LAND REDEVELOPMENT COMMITTEE

Date: 8 September 2025
Item 2.1: Lot 9500 Rowley Road, Hilbert – Development Application Determination
Submitted by: Matt Ryan

Project Area: Wungong Urban Water
Location: Lot 9500 Rowley Road, Hilbert
Owner: Coles Group Property Developments Ltd
Applicant: Element Advisory (Part of SLR)
Proposal: Neighbourhood Activity Centre (Shopping Complex, Liquor Store, Café/Restaurant and Child Care Premises)

HILBERT NEIGHBOURHOOD CENTRE LANDSCAPE CONCEPT PLAN

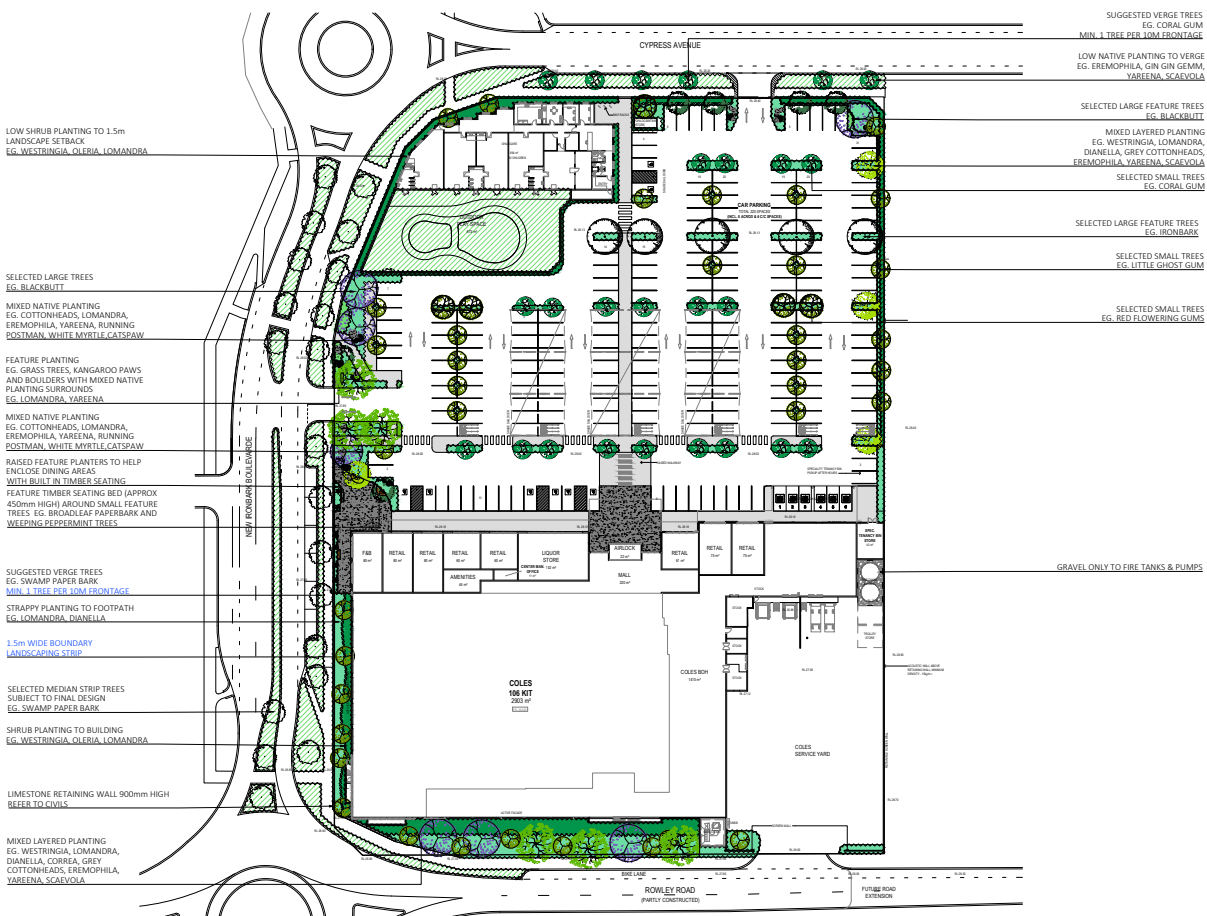
Provide justification for the proposed shade canopy structures in the car park in lieu of trees. The use of large canopy trees to provide shelter is encouraged.	The balance between shade canopy structures and an external perimeter of screening shade trees in the car park is considered appropriate to meet customer expectations for shade to their vehicles whilst providing the longer term opportunity for large canopy trees to grow and provide shelter in other parts of the car park. This arrangement has been deployed successfully on other Coles centre developments including at Currambine and Florida Beach (see attached plans) and has been accepted by the State Design Review Panel (SDRP) as an appropriate and well considered response to the need for shelter. It	The proposed shade canopy is considered to be an appropriate outcome and is consistent with shade structure outcomes approved on similar developments with the Wungong Urban Water Project Area and comparable with outcomes across the State. The Design Guidelines requires shade trees are provided to all at grade car parks at a minimum rate of 1 tree to 4 car bays, to ensure appropriate protection from the elements and to assist in breaking up any significant expanse of parking area. The development proposes 220 car bays, requiring 55 shade trees. In

LRC Comment	Applicant Response	DevelopmentWA Consideration
	is also a comparable design outcome to that accepted by DWA at Sienna Woods (refer attached plans). To enforce a scenario where the shade canopy structures are required to be removed and replaced by trees would place Coles at a competitive disadvantage to other centres with shade structures, including at Sienna Woods, and is not acceptable.	response to this requirement, the development proposes 89 shade trees across the site, exceeding the requirement and ensuring the provision of adequate shade and landscaping.
Explore opportunities to better disperse trolley collection areas throughout the car park.	The project architects have confirmed that it is possible to provide trolley bays further north in the car park area. A condition requiring improved dispersal of trolley collection areas throughout the car park is acceptable.	A condition is recommended for inclusion on the Form 2 Approval requiring an Operational Management Plan to be provided at condition clearance stage. The management plan should include details on the management of shopping trolleys (storage and retrieval) throughout the car park. The plans are to be updated to improve the dispersal of trolley collection areas throughout the car park.
